1 Denison Street
North Sydney, NSW 2060
General Arrangement Plan
Level 24 - Typical High Rise

Scale	1 : 250 @ A1
Drawn	MDJ Checked AD
Project no.	s12055
Status	Development Application
Plot Date	9/05/2018 12:07:58 PM
BIM	1DENISON_BS_ARCH
Drawing no.	DA03.024
Revision	5

**1 Denison Street
North Sydney, NSW 2060**
Building Elevations
North Elevation

Scale	1 : 250	@ A1
Drawn	MJU	Checked
Project no.	S12025	AD
Status	Development Application	
Plot Date	30/05/2018 12:17:58 PM	
BIM	1 DENISON_SB_ARCH	
Drawing No.	DA07.101	Revision
		5

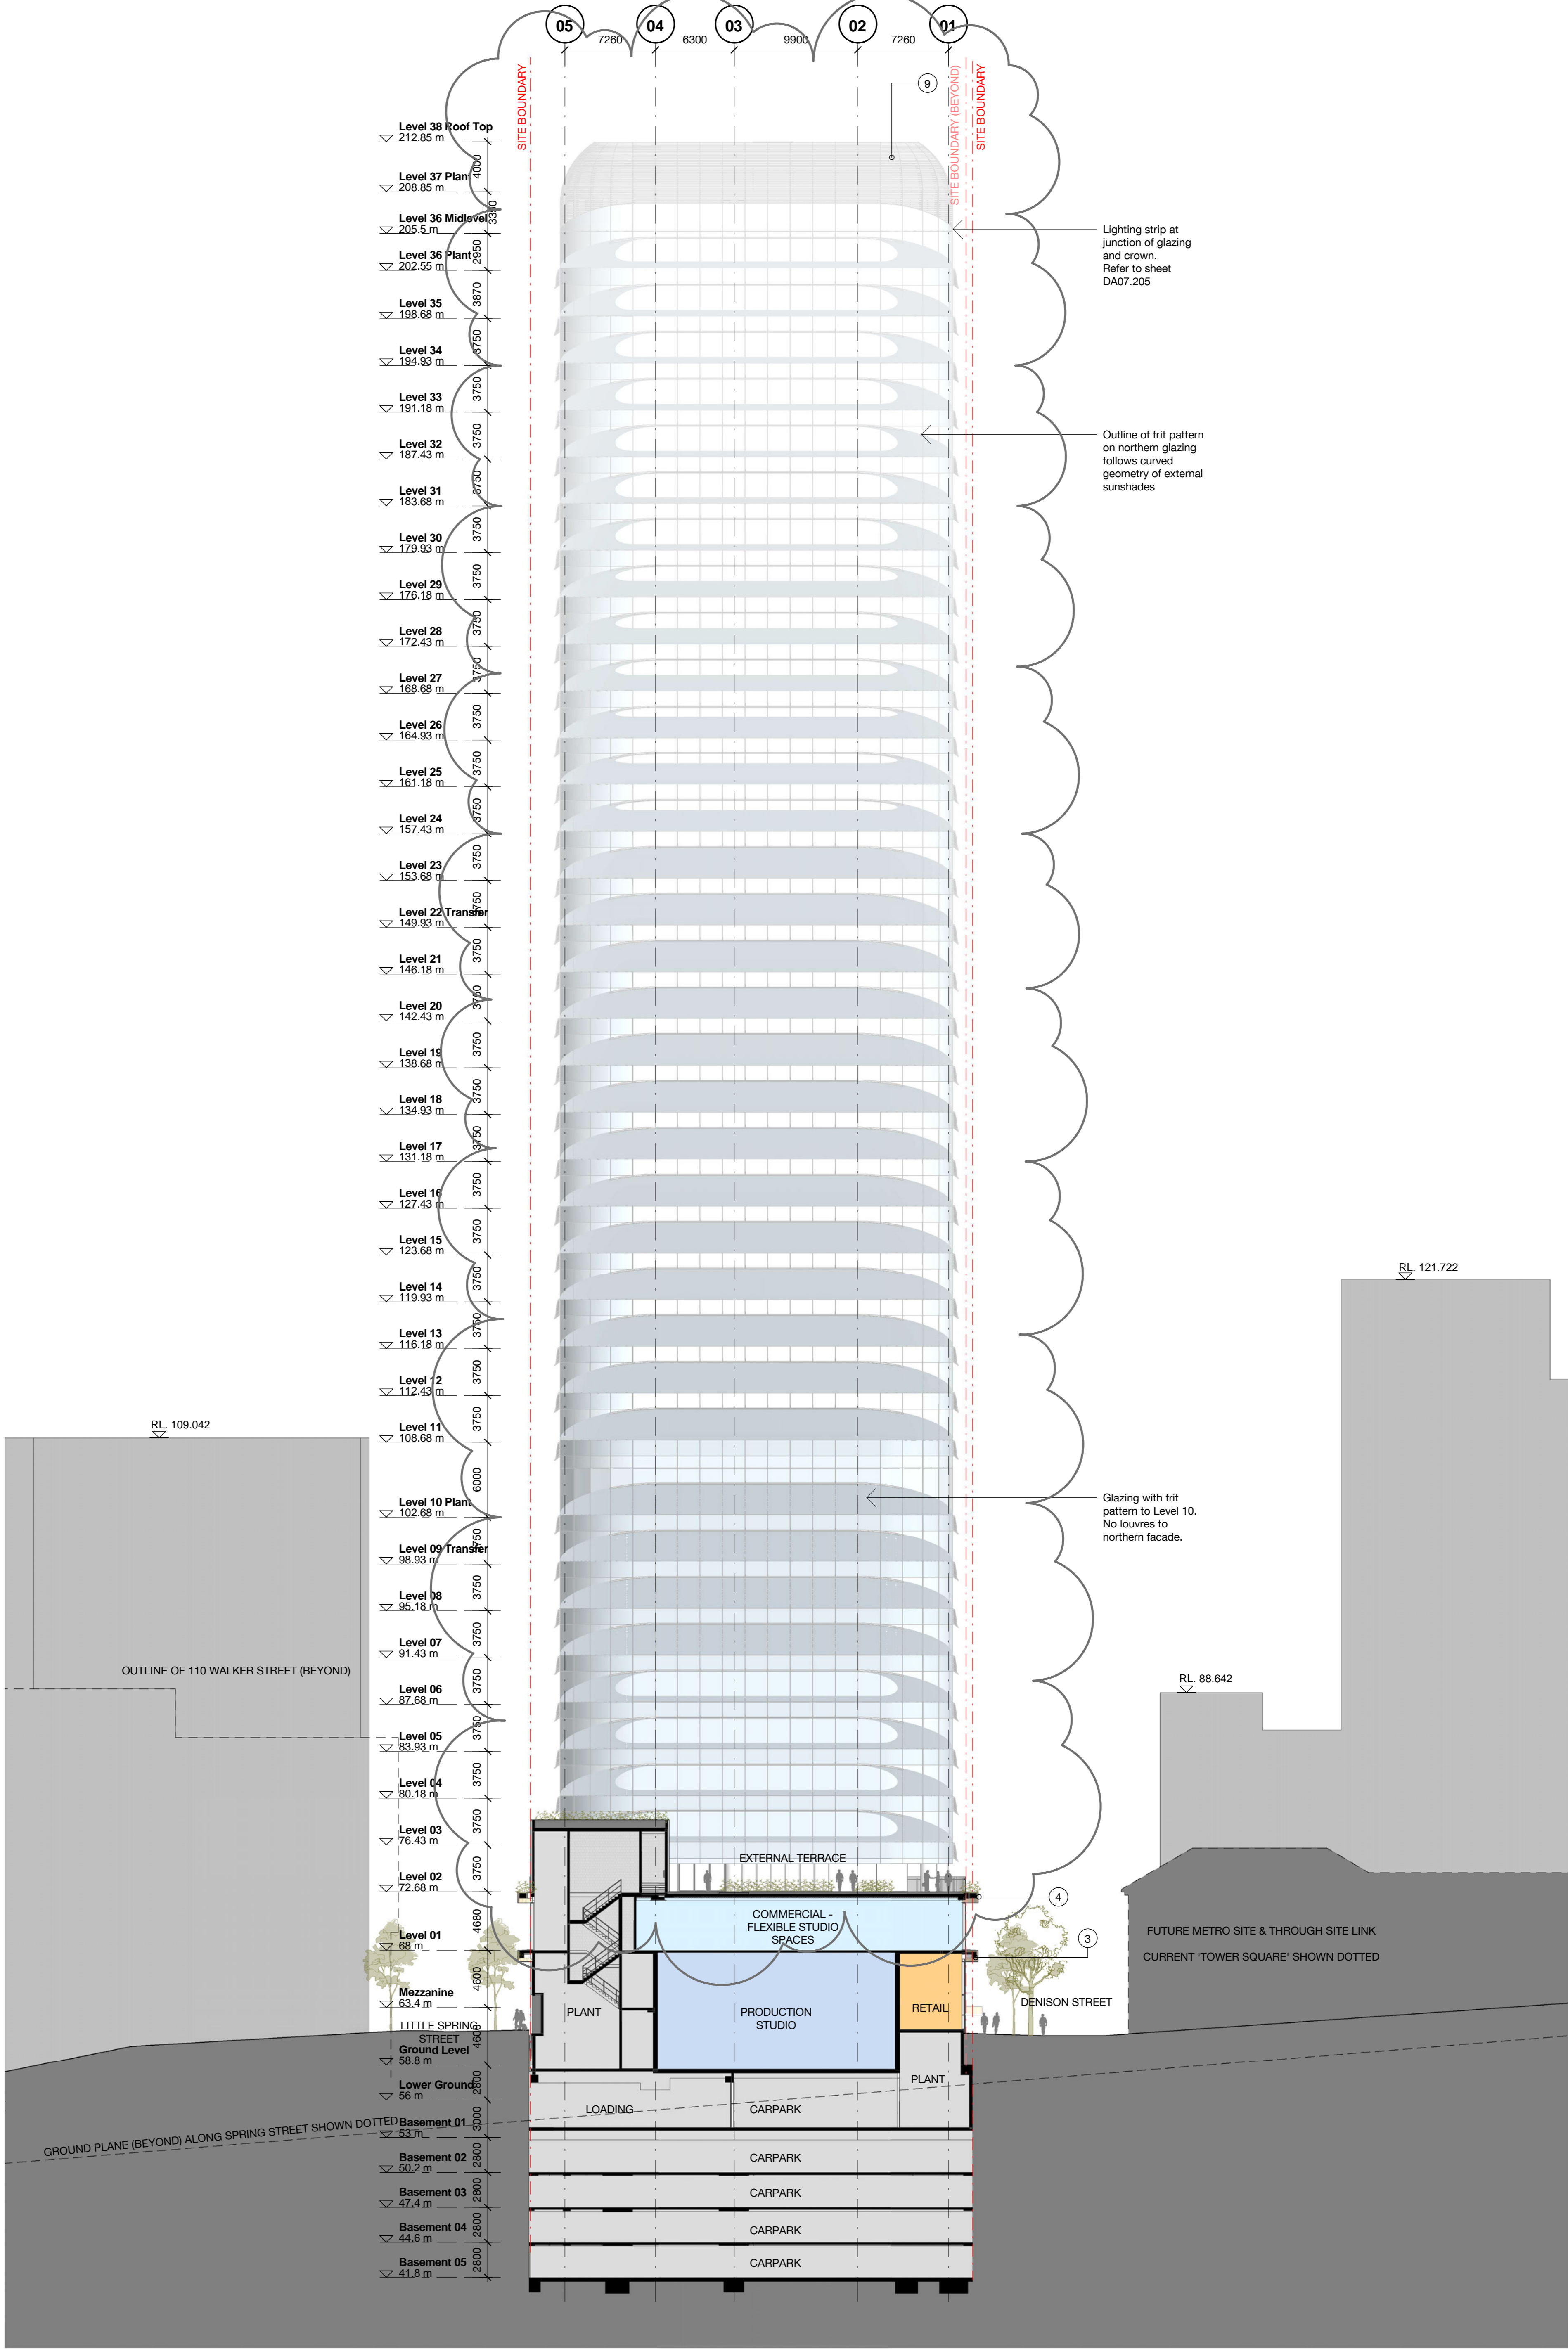
Lighting strip at junction of glazing and crown. Refer to sheet DA07.205

Outline of frit pattern on northern glazing follows curved geometry of external sunshades

Glazing with frit pattern to Level 10. No louvres to northern facade.

No changes proposed to building envelope. Modifications to facade treatments only.

Alignment of lower edge of rooftop crown has been adjusted on east and west facades

Rounded corners to louvres
